Year 2 Monitoring Report

MATTHEW SITE

NCDMS Project #100043 (Contract #7419)
USACE Action ID: SAW-2017-00055
DWR Project #2017-0624

Subject: Matthew MY2 Comments, Project ID #100043, DMS Contract #0007419

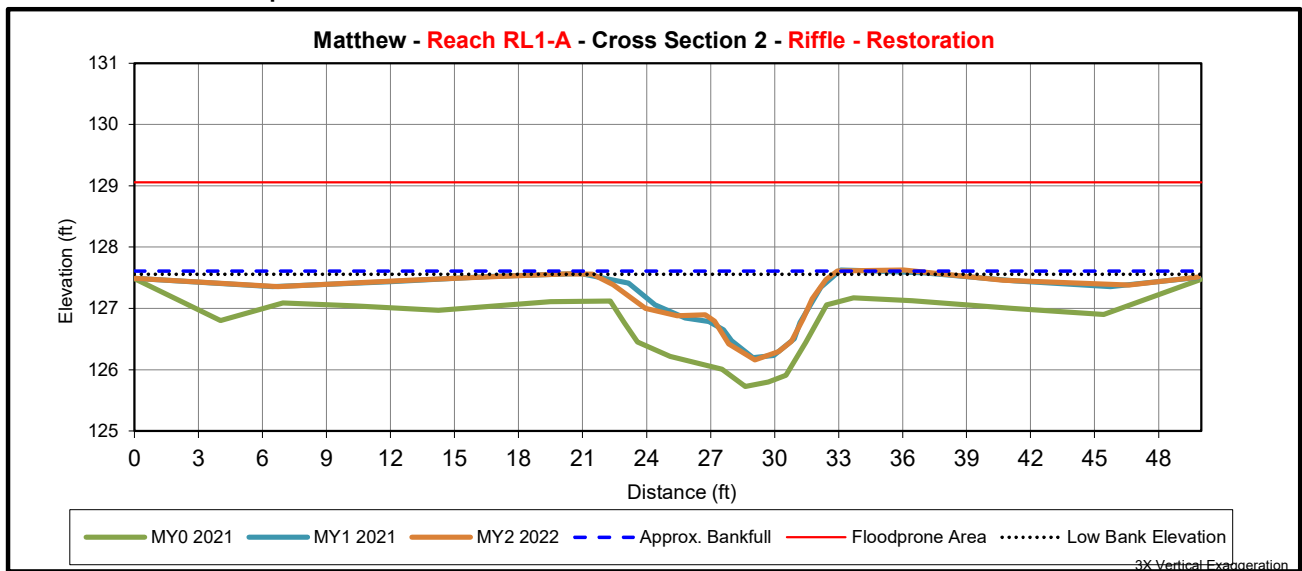
1. Please QA/QC cross section data for accuracy. For example, XS 2 shows a greater than 25% reduction in cross sectional area between AB and MY1, then an increase in cross sectional area (6.1 to 8.0) between MY1 And MY2. Are these estimates in error or do they reflect a large change in cross sectional area?

The reduction in cross sectional area between MY0 and MY1 was legitimate and was due to some aggradation of sediment coming into the top of the Project. However, the actual channel dimension remained stable and almost identical between MY1 and MY2, but the “top-of-bank calls” (which is where we set Low TOB and BF Stage elevations for the sake of calculating cross sectional area) appears somewhat subjective and not perfectly consistent between MY1 and MY2 even though the channel was virtually unchanged. Sometimes there is discrepancy in such calls simply due to surveyor subjectivity and/or a physical “obstacle” in the field while surveying, such as a thick clump of juncus on the TOB or even minor bank sluffing due to the surveyor’s boot walking up the bank. In reality, these are not substantial changes in the channel dimension but can appear to skew the calculated cross sectional area and is especially exaggerated for smaller channels.
